Development Control Committee Tuesday, 2 March 2021 6.30 p.m.

3. PLANNING APPLICATIONS TO BE DETERMINED BY THE COMMITTEE	
(A) 20/00153/FUL - Proposed development comprising 249 dwellings, reconfiguration of Golf Course, demolition of existing clubhouse and associated buildings and erection of new clubhouse and greenkeepers store, creation of new vehicular accesses, roads, car parking ancillary development at Widnes Golf Club, Highfield Road, Widnes, WA8 7DT.	5 - 153

APPLICATION NO:	20/00153/FUL
LOCATION:	Widnes Golf Club, Highfield Road, Widnes, WA8 7DT.
PROPOSAL:	Proposed development comprising 249 dwellings, reconfiguration of golf course, demolition of existing clubhouse and associated buildings and erection of new clubhouse and greenkeepers store, creation of new vehicular accesses, roads, car parking and ancillary development.
WARD:	Kingsway
PARISH:	None
APPLICANT:	Widnes Golf Club, Highfield Road, Widnes, WA8 7DT.
AGENT:	Barton Willmore, Tower 12, Bridge Street, Spinningfields, Manchester, M3 3BZ.
DEVELOPMENT PLAN: Halton Unitary Development Plan (2005) Halton Core Strategy (2013) Joint Merseyside and Halton Waste Local Plan (2013)	ALLOCATIONS: Greenspace (Golf Course) and

Figure 1. Modelled Baseline Scenario 1% AEP Event

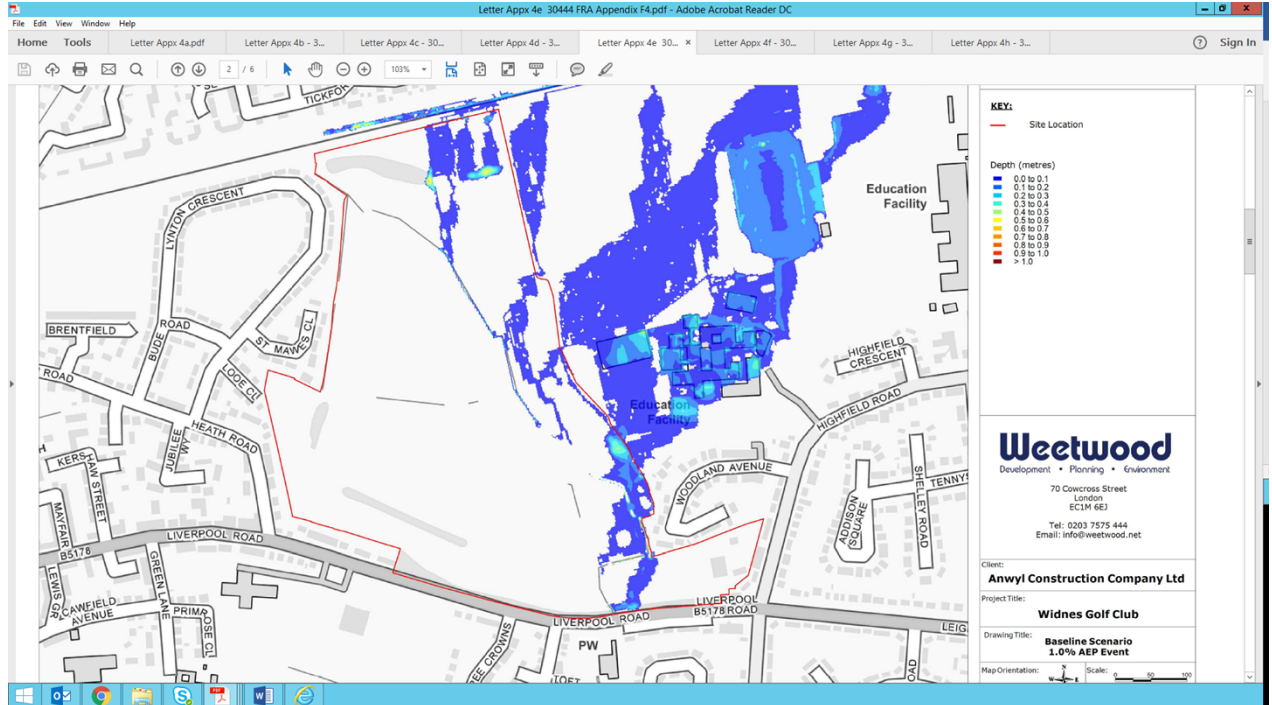
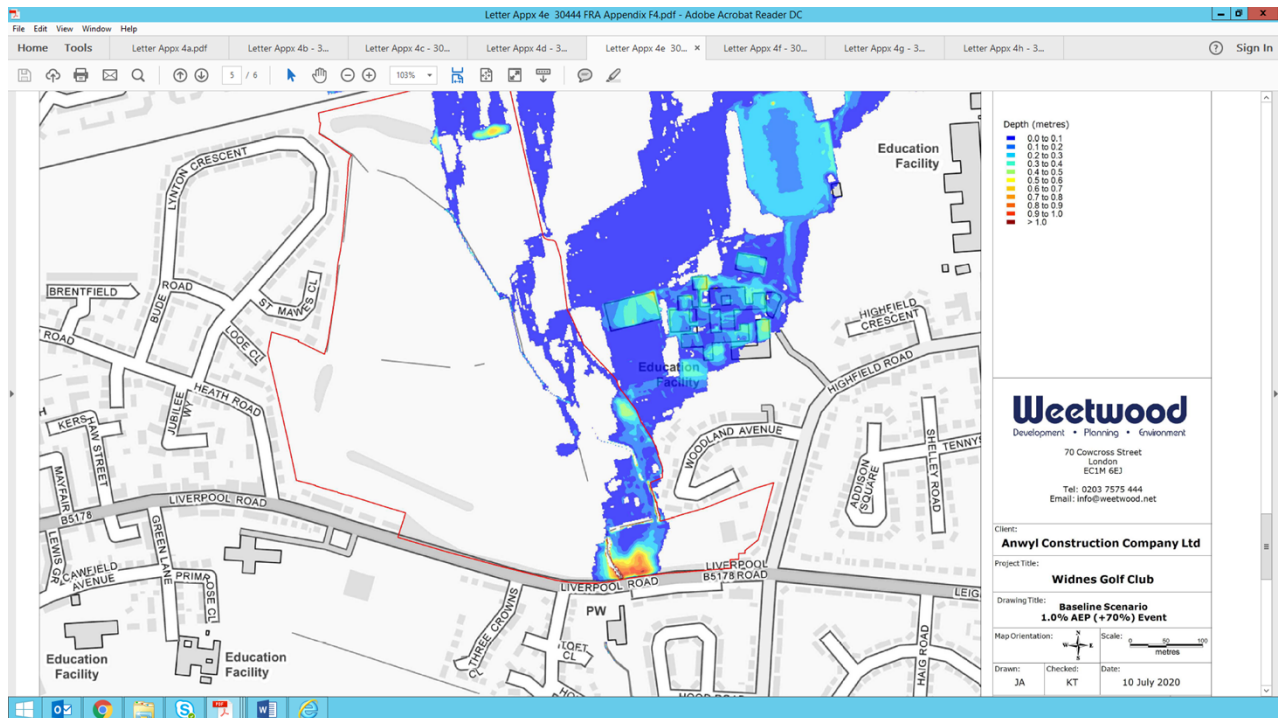
- Baseline Flood Extent have been provided in Annex E and can be seen if Figures 1 and 2 below. They show a significant extent of fluvial flood risk surrounding Moss Brook in the 1% AEP event and events of greater magnitudes. The LLFA would also note it is unclear as to what magnitude event the flooding starts to occur and the mechanism for flooding.

- Furthermore the LLFA would like to note both Paragraph 033 of the Environment Agency Flood Risk and Coastal Change Guidance (Reference ID: 7-033-20140306) and Paragraph 155 to 158 of the NPPF indicate the sequential approach to locating development in areas at lower flood risk should be applied to all sources of flooding and inappropriate development in areas at risk of flooding should be avoided by directing development away from areas at highest risk (whether existing or future). Paragraph 163 of the NPPF goes on to state 'Development should only be allowed in areas at risk of flooding where, in the light of this assessment (and the sequential and exception tests, as applicable) it can be demonstrated that: a) within the site, the most vulnerable development is located in areas of lowest flood risk'.

- The LLFA would therefore object to the proposed development of 'More Vulnerable' infrastructure within the modelled flood extent of Moss Brook shown in Annex E of the FRA, particularly when there is a significant area of the site which does not lie within the modelled flood extents and would be more suitable for development of residential dwellings.

Figure 3. Proposed Scenario 1% AEP Event

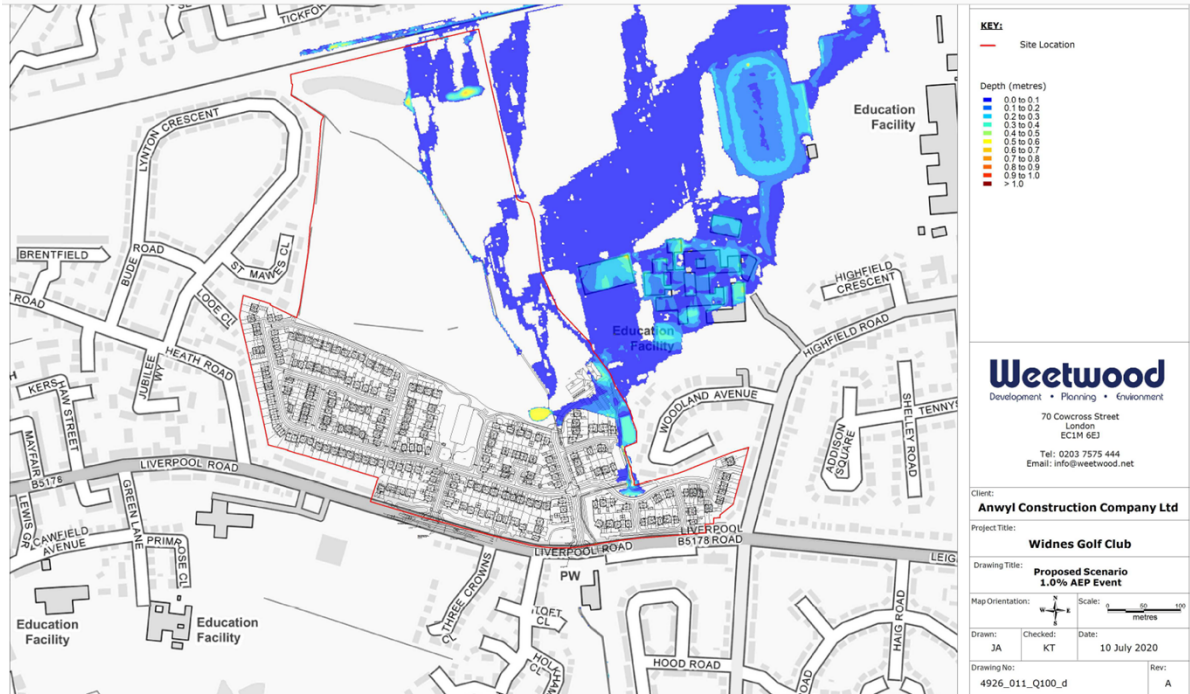
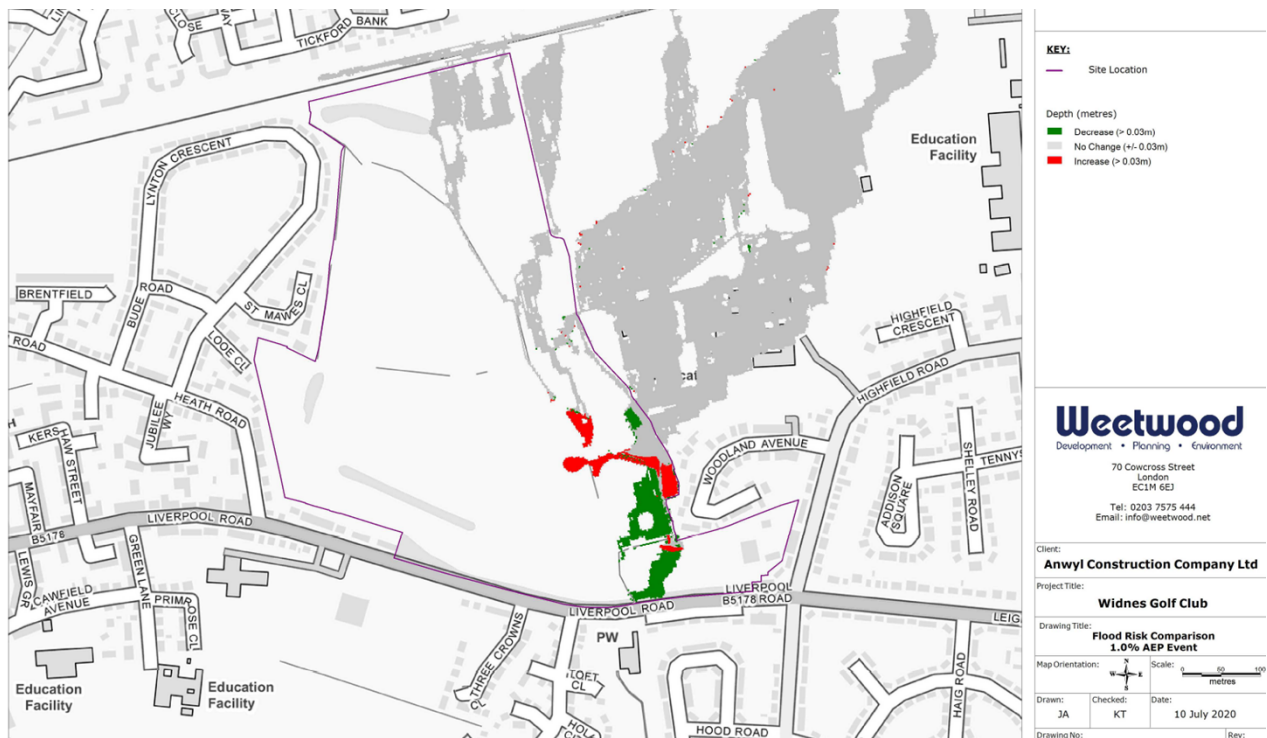
- The LLFA would like to note, although this is the case for the 1 in 100 year event as shown in Figures 3 and 5, Figure 4 shows flood risk has increased to the properties on Woodland Avenue. There are four properties on Woodland Avenue shown to have minor garden flooding up to 0.1m in the baseline scenario, that in the proposed scenario are shown to be well within the flood outline, indicating a potential for internal property flooding and with their

gardens potentially experiencing flood depths of up to 0.6m. This is unacceptable and clearly does not follow NPPF or EA guidance by the proposed development increasing flood risk elsewhere.

Figure 4. Proposed Scenario 0.1% AEP Event

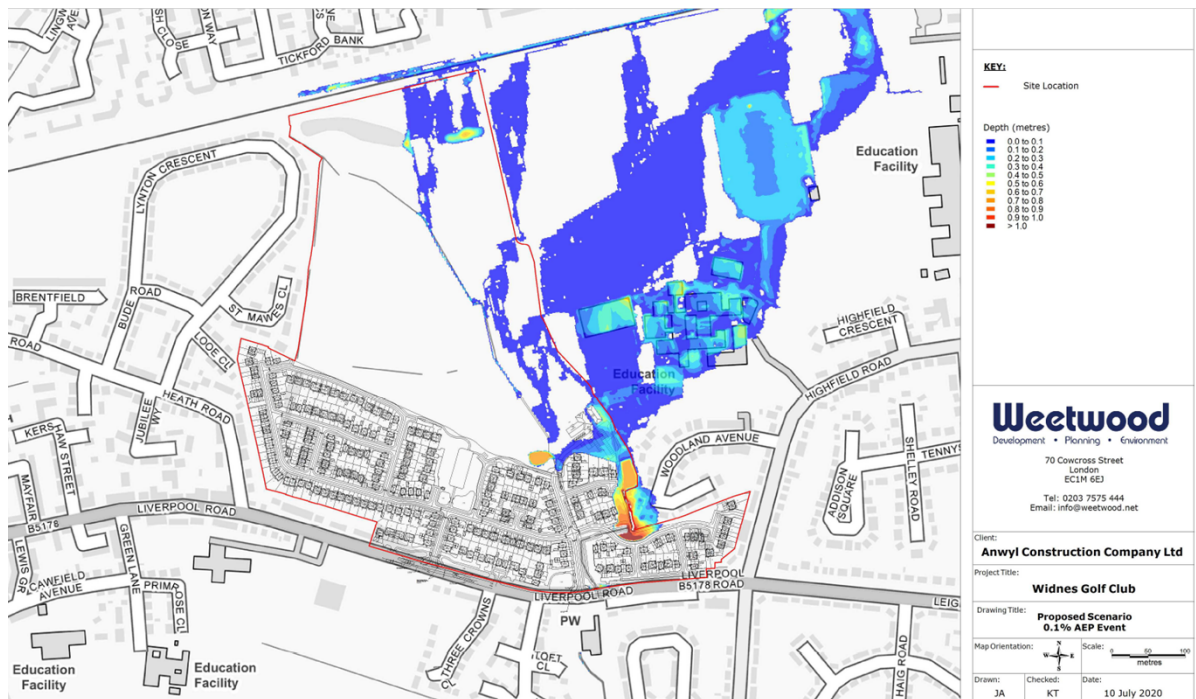
4. Figure 4 shows flood risk has increased to the properties on Woodland Avenue. This is unacceptable and clearly does not follow NPPF or EA guidance by the proposed development increasing flood risk elsewhere.

12. Figure 4 shows flood risk has increased to the properties on Woodland Avenue. This is unacceptable and clearly does not follow NPPF or EA guidance by the proposed development increasing flood risk elsewhere.
